**Submission to Minister for Transport
With respect to the public inquiry concerning the Kildare Route
Project**

Platform 11 Dublin Rail Projects Committee¹

November 25, 2005

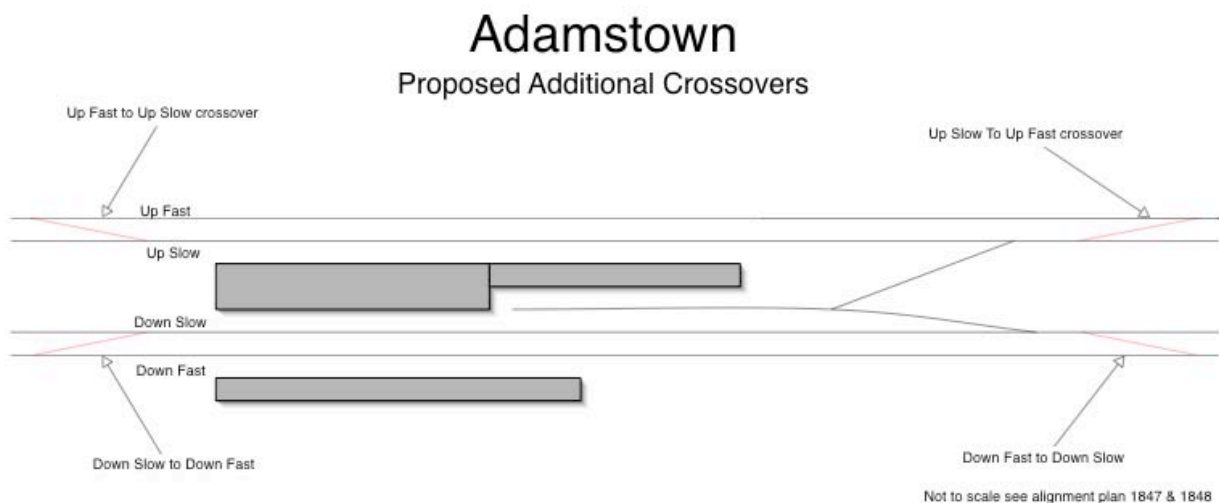
It would appear logical to place such crossovers at Adamstown. We propose 4 crossovers, (please see below sketch) these will allow the flexibility to allow trains to cross from the fast to slow lines, allow trains on the fast lines to access the turn back siding at Adamstown thus maximising the flexibility of the 4 track section.
